Scope

This document highlights the precautions necessary to ensure electrical isolation of the SPIRE FPU.

LI Interface

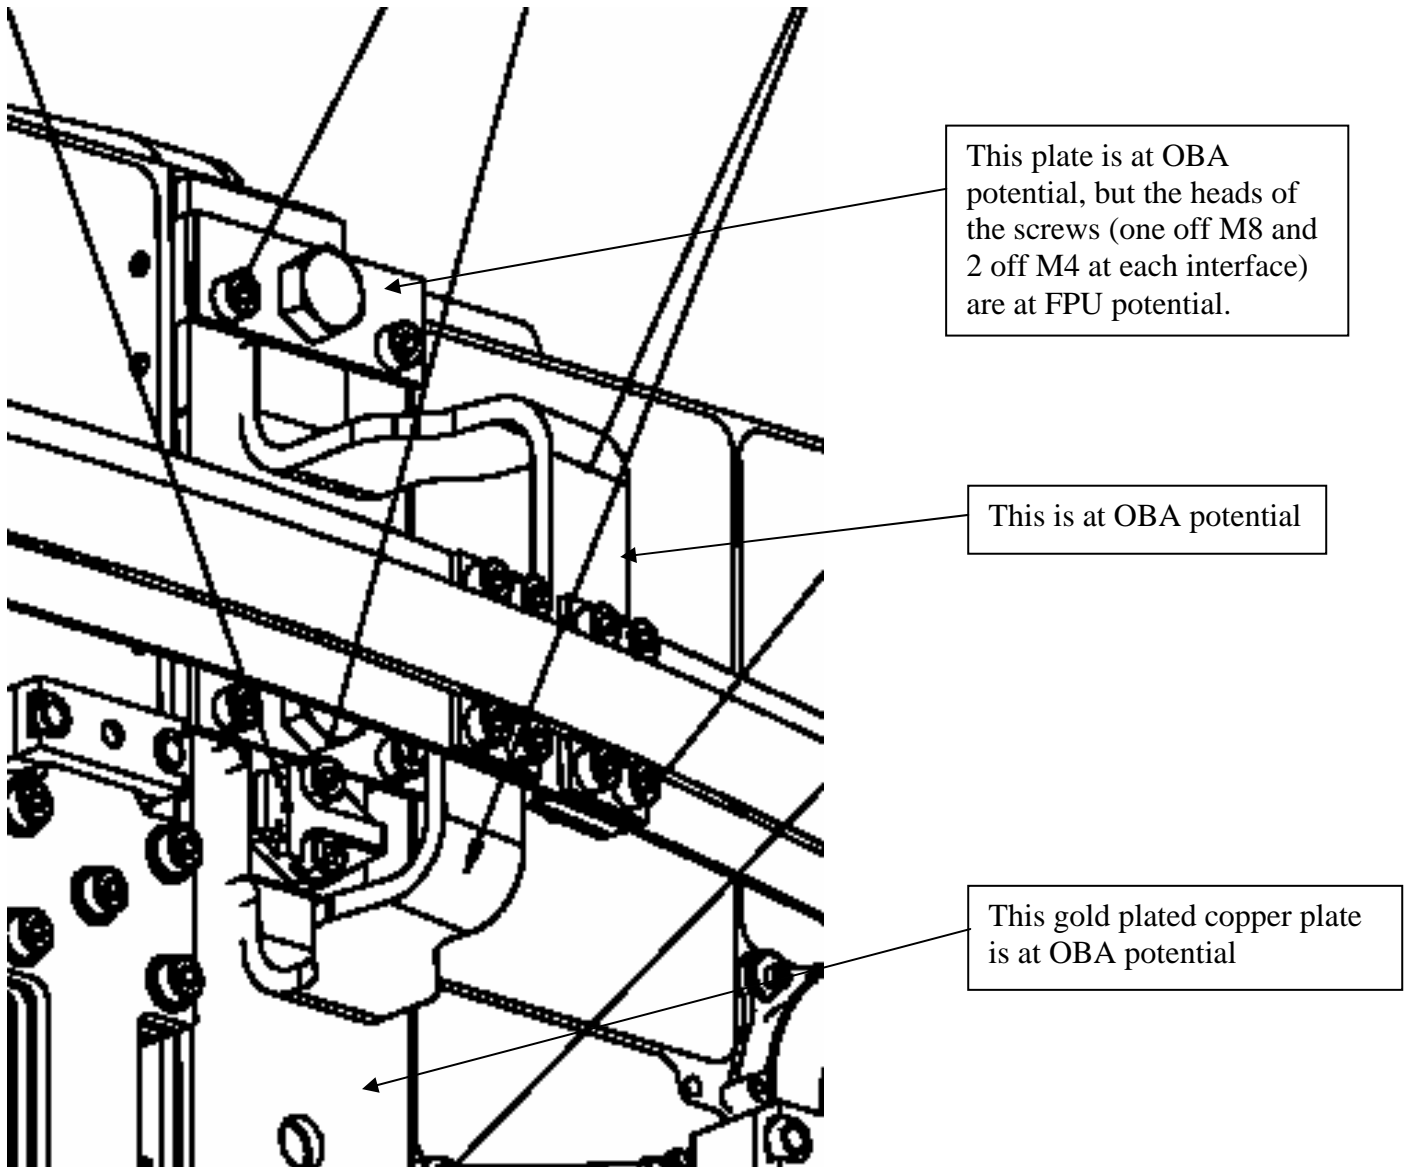
This is critical as the isolating joint is at the interface to the FPU. The plate which clamps the L1 strap is at OBA potential, but the heads of the screws (one off M8 and 2 off M4 at each interface) are at FPU potential. There is only a small gap between objects which are isolated. All conductive film and tape should be avoided in this area.
